**GOULBURN RIVER SOLAR FARM**

Amendment Report

December 2023

Prepared by  
Umwelt (Australia) Pty Limited  
on behalf of  
Lightsource bp

**FIGURE 3.8**  
Amended Project - Revised Western Extent of the Project Layout to Avoid TSR 44841

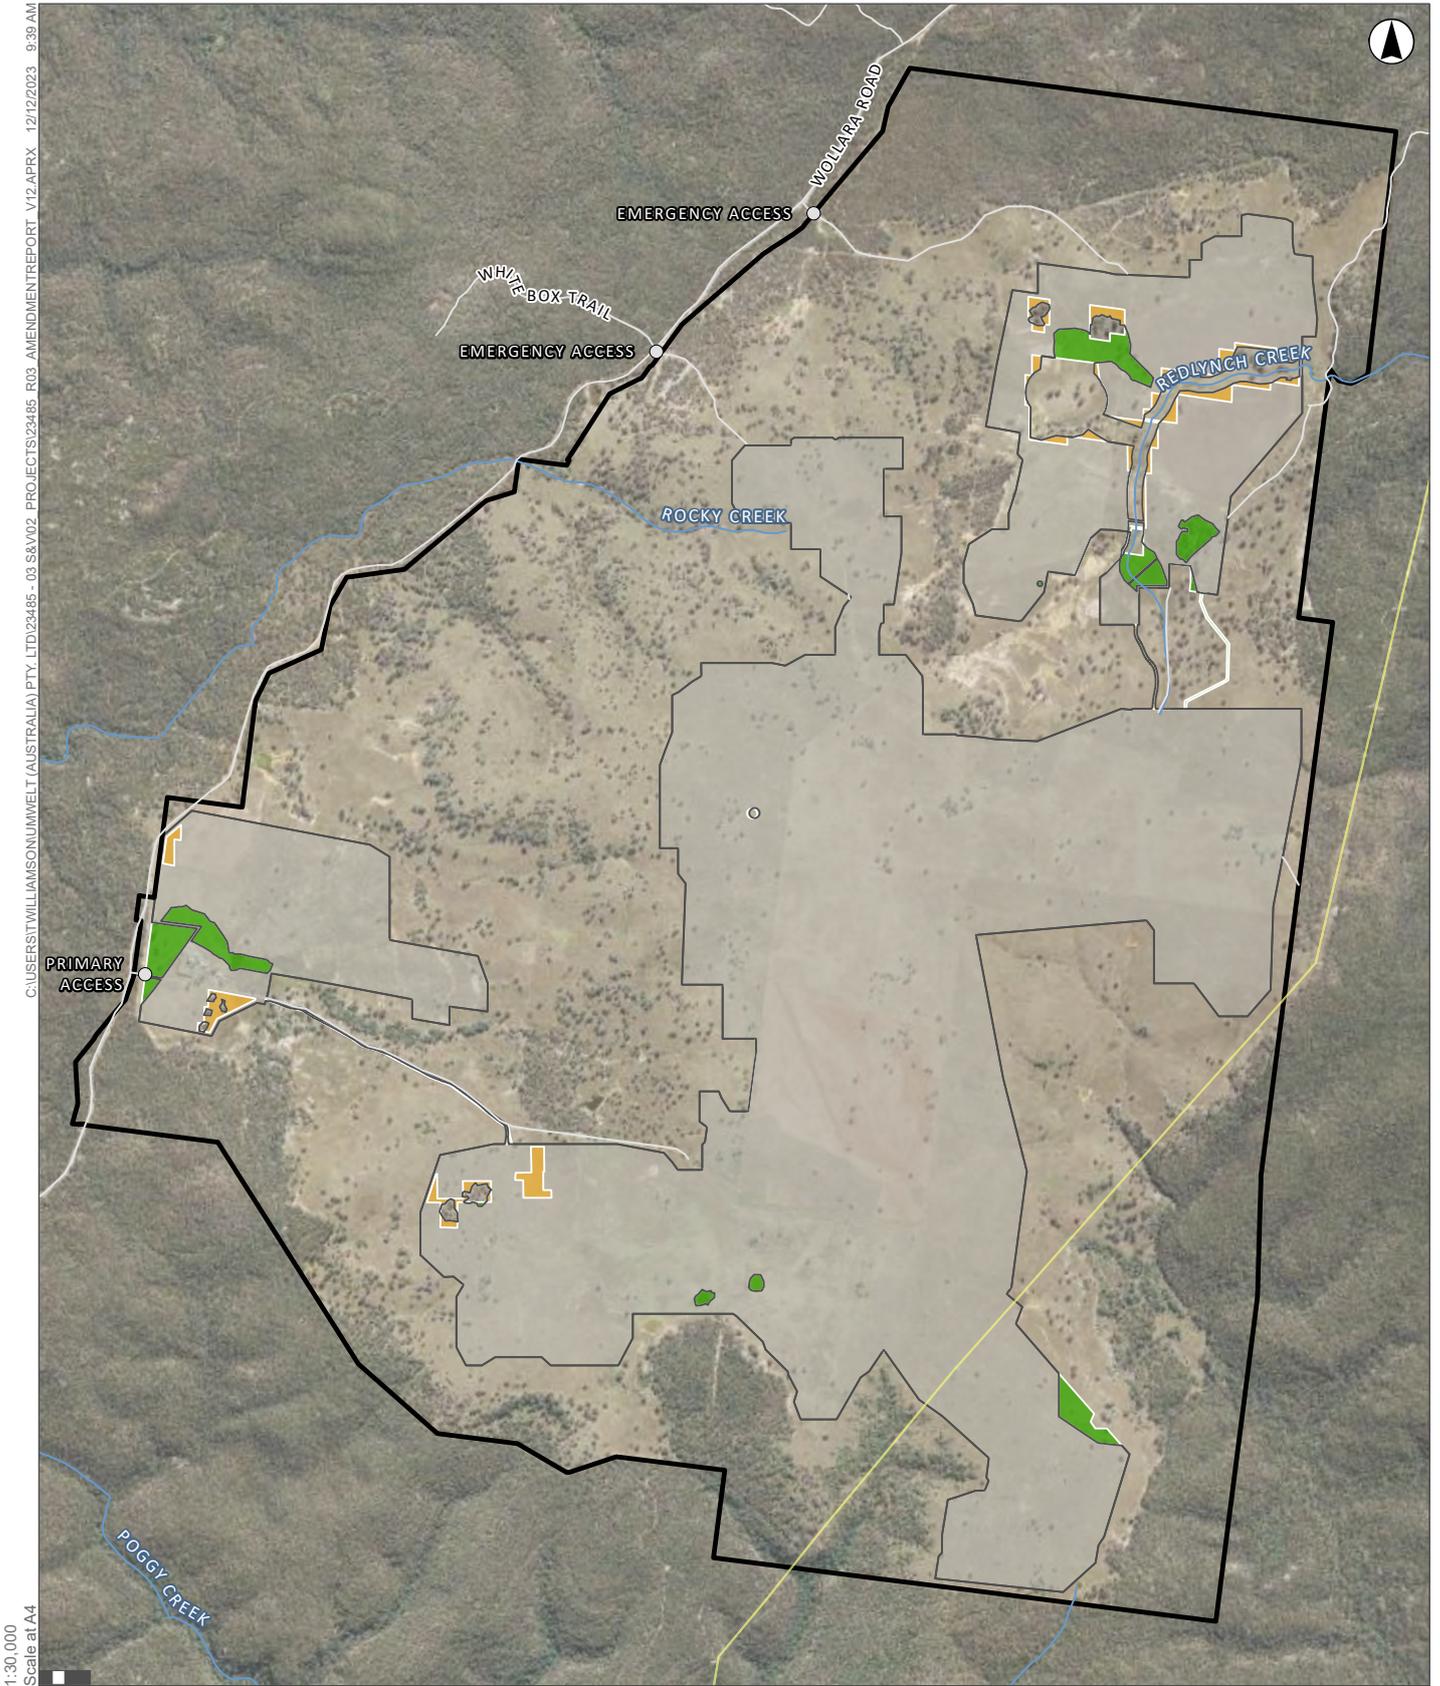
Further consultation with DPE – Crown Lands following public exhibition of the Project EIS has resulted in a minor realignment of the Development Footprint to avoid overlapping with TSR 44841. The western extent of the Project Area is now proposed to extend towards the east and will avoid TSR 44841. The revised Project Area and Development Footprint is outlined on **Figure 3.6** below. TSR 44841 will remain as a site access point, utilising the existing access track.
